Boston Edison

Supplementary Information on
Augmented Examination of Reactor Pressure Vessel Shell Welds Conducted
Pursuant to 10 CFR 50.55a(g)(6)(ii)(A)(2)

Supplementary Information on Augmented Examination of RPV Shell Welds

Coverage Patch 01

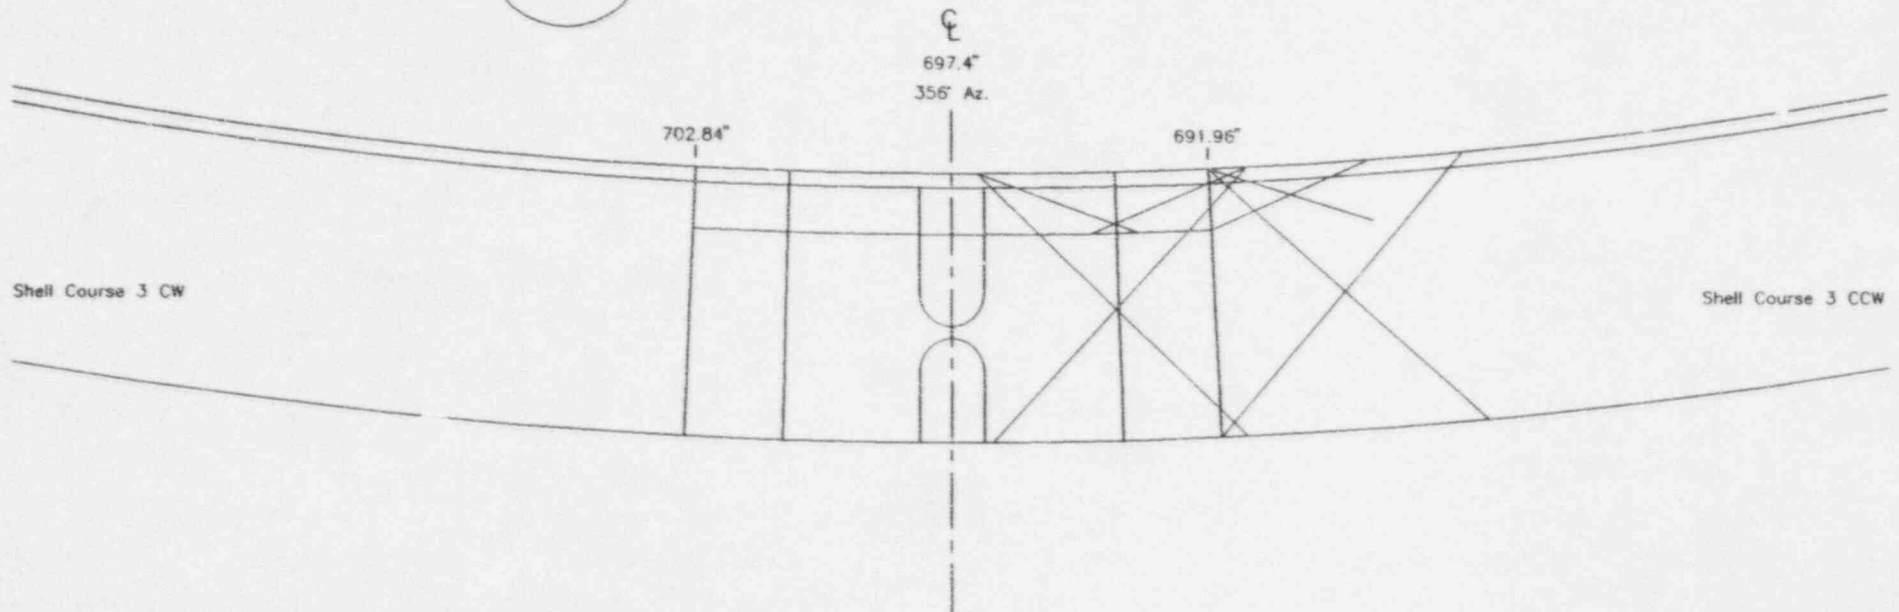
Welds RPV-L-2-339A and RPV-L-1-339B have access restrictions caused by welded guide rods at vessel azimuth 0° and 180° (see attached figure). The guide rod is directly over the RPV-L-1-339B weld and affords no access for scanning, thus coverage is specified as "0". The RPV-L-2-333A weld has restrictions caused by feedwater spargers and core spray piping, and is offset from the guide rod by 4°; so a small portion of the weld is accessible for examination. The coverage as calculated by the examination contractor (GE) was 3% of the total volume required. The RPV-L-1-338C weld achieved 34.7% volume coverage due to jet pump riser and surveillance specimen brackets interference, with no interference from guide rods.
